# Replacement Figures for Clause 47 of P802.1Qcz

**New Figure 47-3**

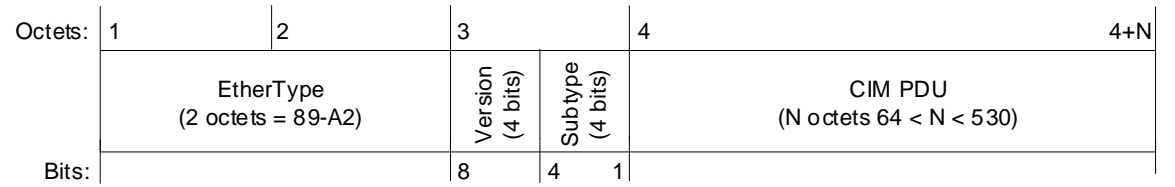
**Table 47-1—Layer-2 CIM Encapsulation**

Octet	Length
PDU EtherType (89-A2)	1	2
Version	3	4 bits
Subtype	3	4 bits
CIM PDU	4	65-529
